REWORK FOR W-101240-1

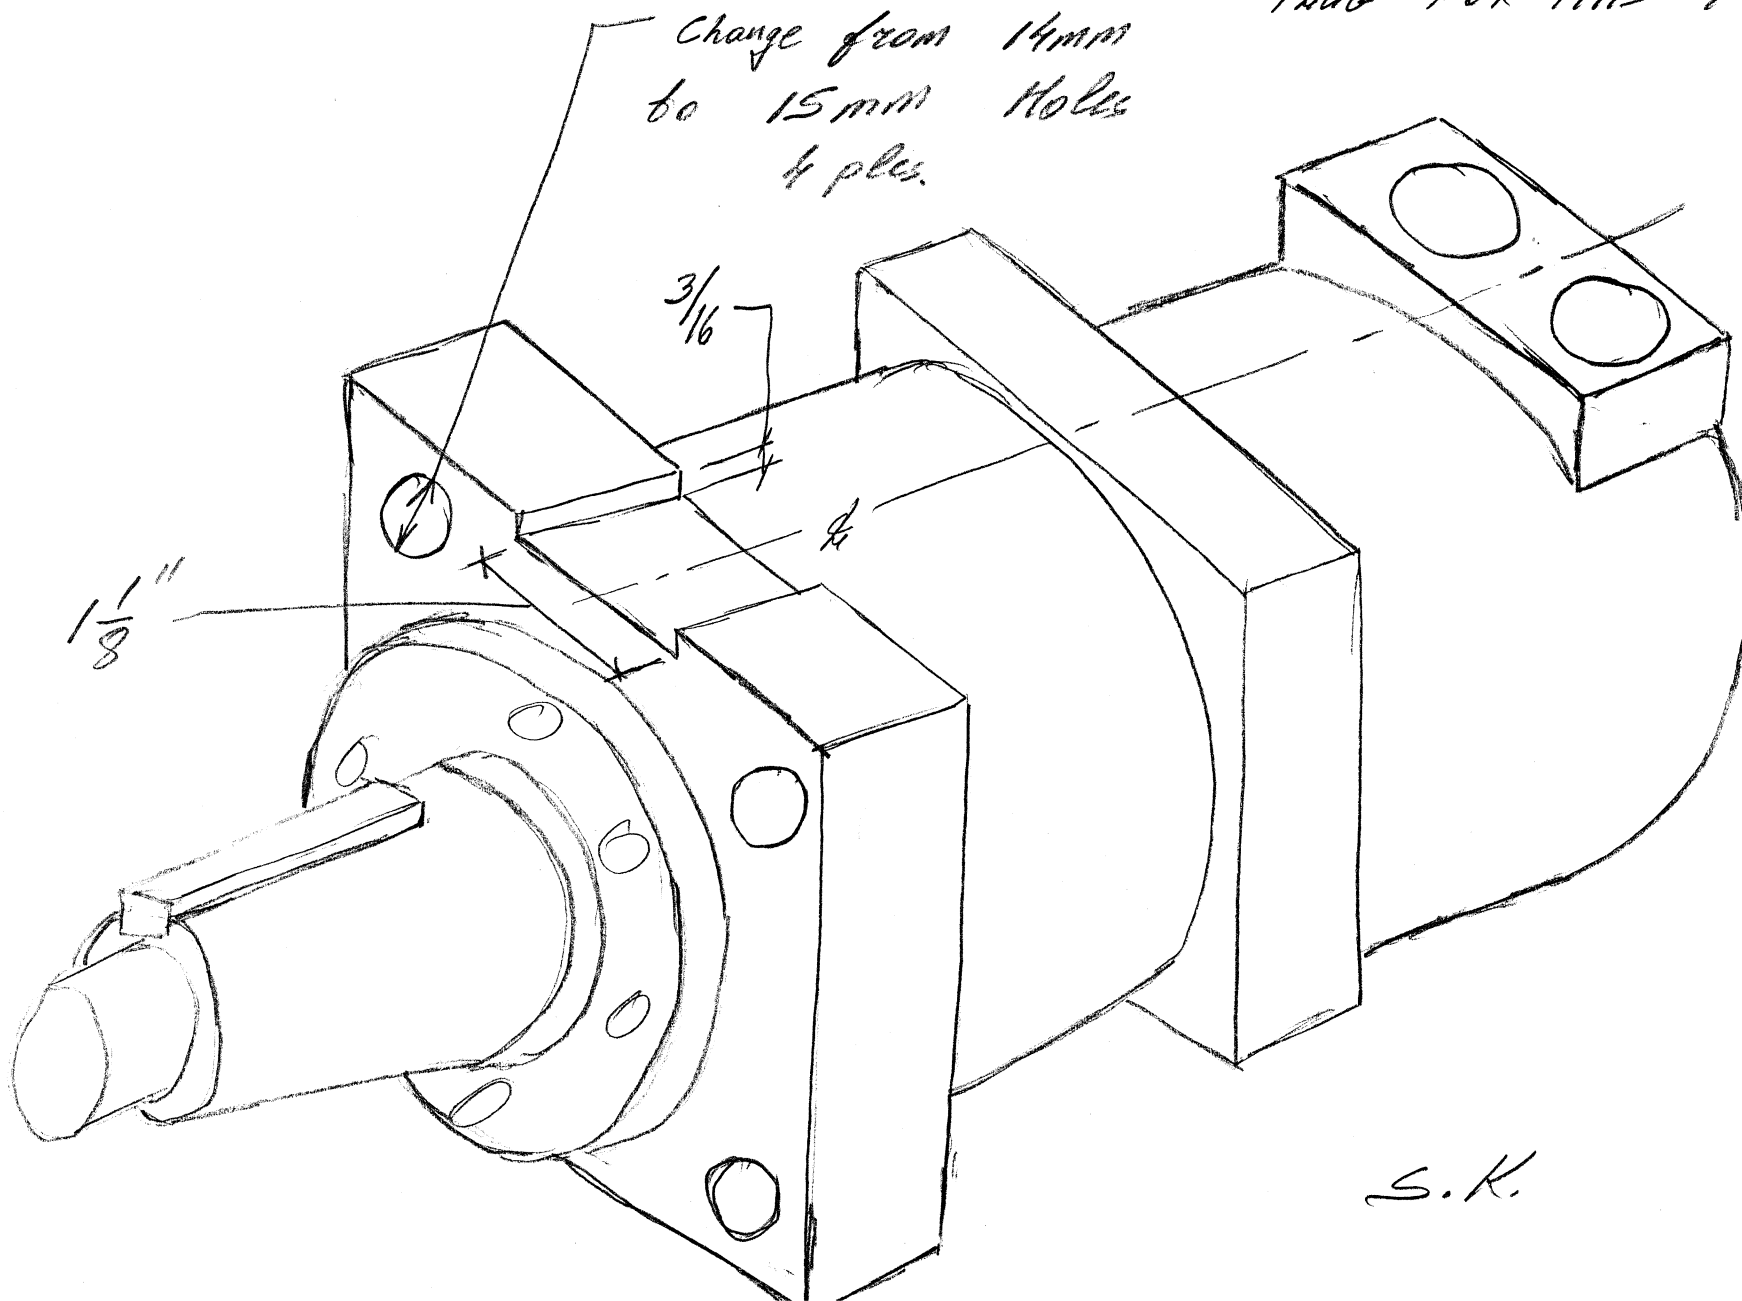
Notes: 1. KEEP THE CASE DRAIN
PORT, ONLY USE A STEEL
PLUG FOR THIS PORT.

Change from 14mm
to 15mm Holes
4 plus.
